Appendix I of RNTPC
Paper No. A/NE-HLH/68B

**APPLICATION FOR PERMISSION
UNDER SECTION 16 OF
THE TOWN PLANNING ORDINANCE
(CAP.131)**

**Proposed Temporary Open Storage and Warehouse (Storage Of Construction Machinery and Construction Materials) for a Period of 3 Years at Lots 171 (Part), 172 (Part), 176 (Part) and 177 (Part) in D.D. 87, Ta Kwu Ling, New Territories
(Planning Application No. A/NE-HLH/68)**

Figure 8

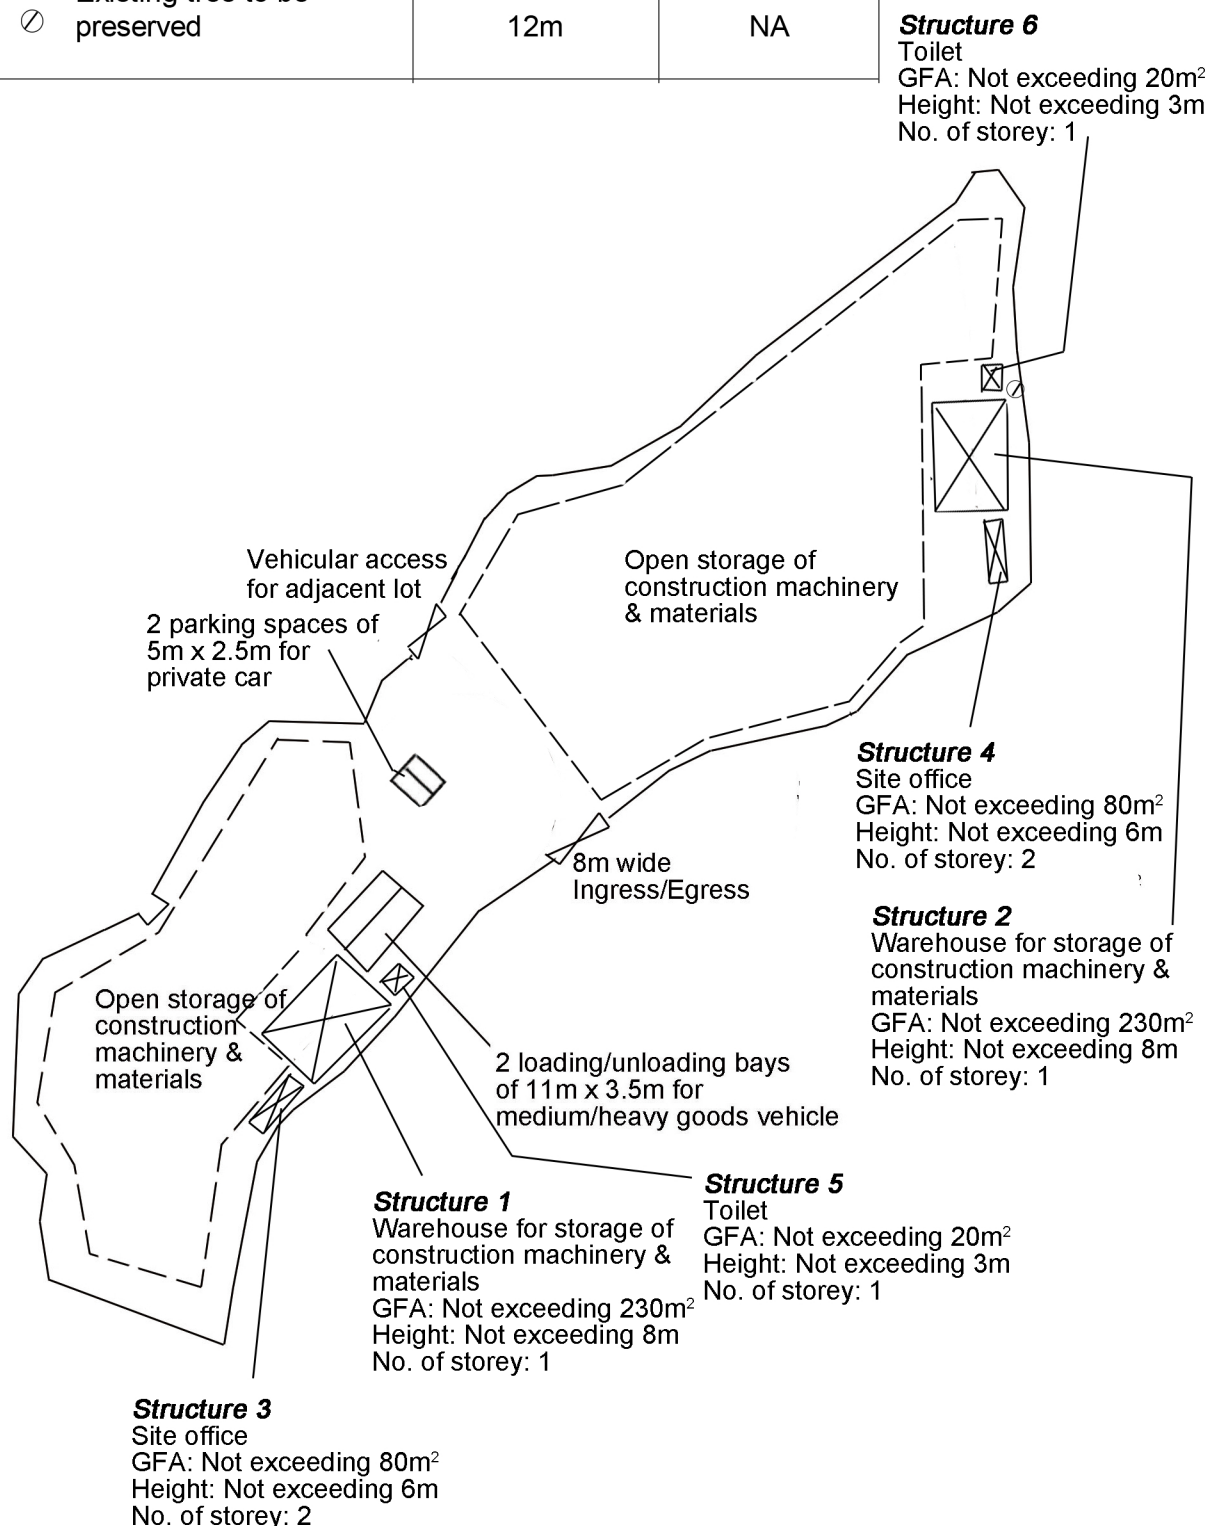
CTP/UD&L, Planning Department's comments	Applicant's response
The applicant is advised to indicate the existing trees within the site on the Layout Plan and the proposed tree treatment (i.e. retain/ transplant/ fell), and mitigation measures, if any.	Please refer to the landscape plan in the attachment. The existing tree will be retained. No storage of materials within 1m of the tree trunk is proposed.

Photo 1470

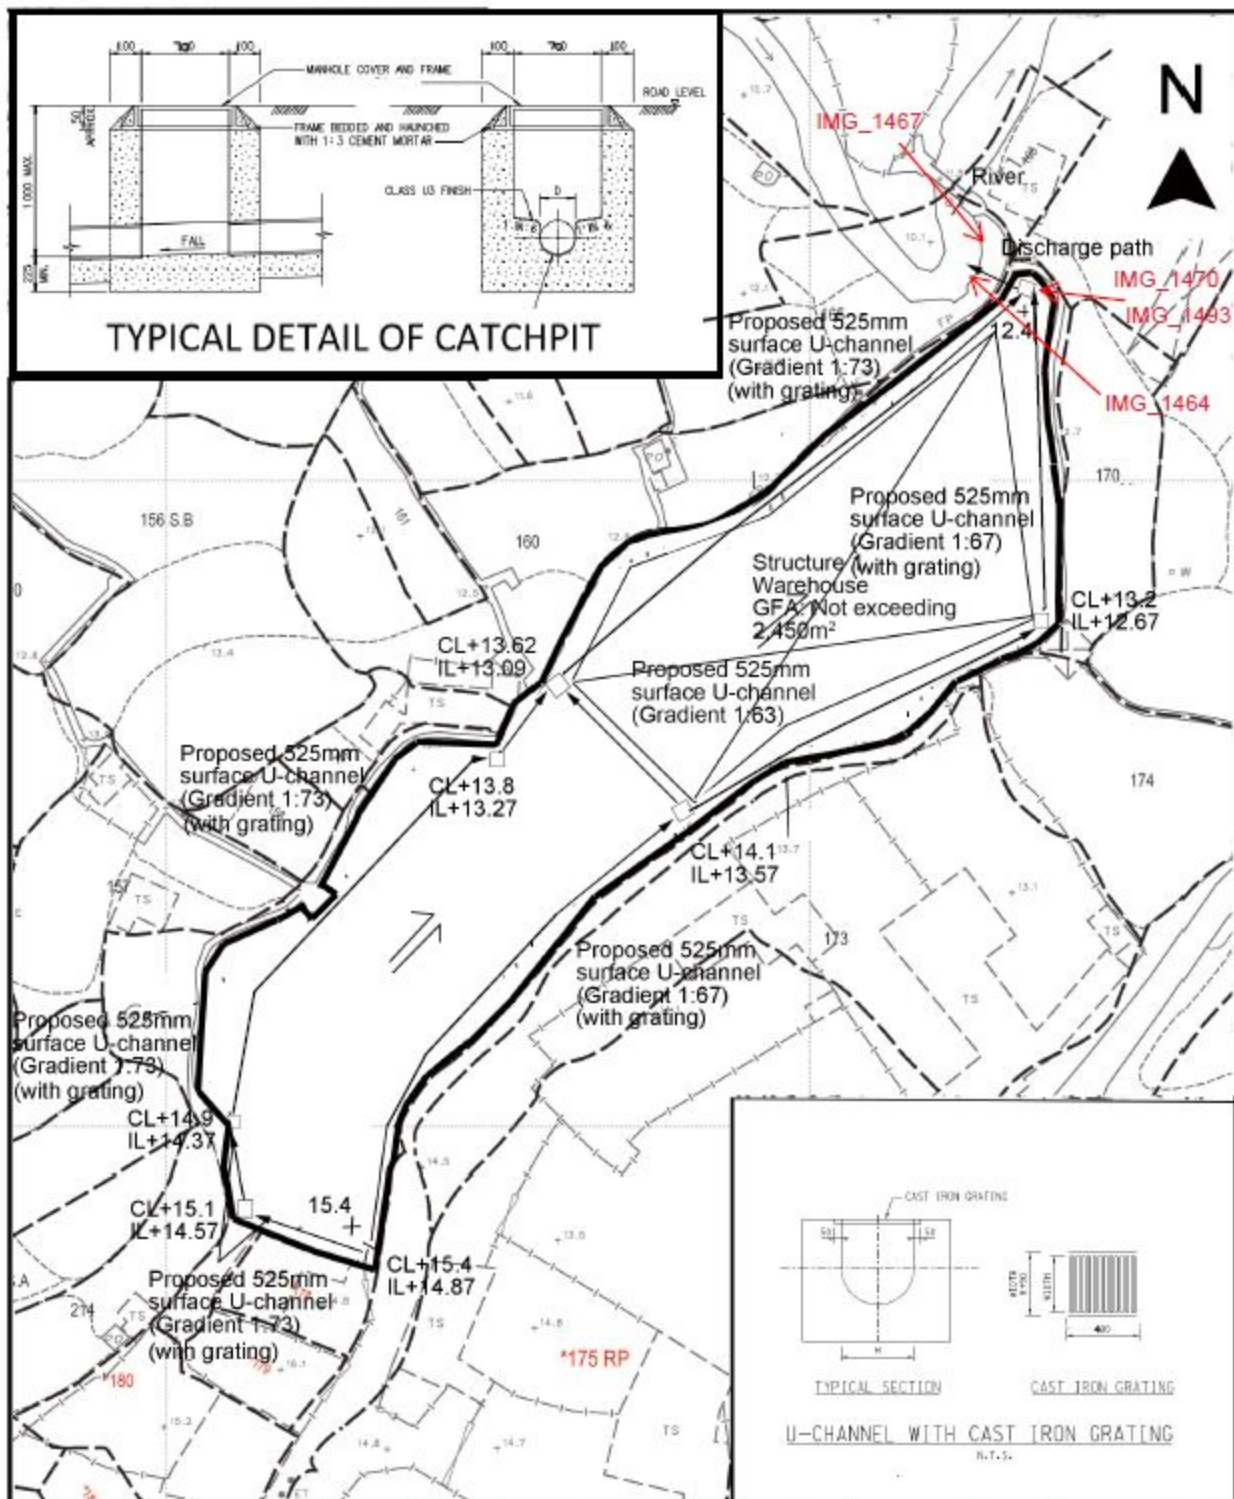
CE/MN, DSD's comments	Applicant's response
<p>1. Please advise engineering details of the proposed flow path, such as U-Channel/drainage pipe/outfall, from the catchpit with sand trap to the nearby watercourse in the proposal.</p> <p>2. A catchpit with covers should be provided where there is a change of direction of the channel/drain. Catchpits are missing at turning locations.</p> <p>3. Please provide more photos of the discharge point and the watercourse in the vicinity, the locations of the camera and the direction of each photo should also be indicated on a plan.</p>	<p>Our response to the comments are found in the attachment. Please see below for the photos of the discharge point and the watercourse in the vicinity. The photo location is shown on the attached drainage plan. Catchpit with covers were provided at the site. Catchpits have been provided at turning points.</p>
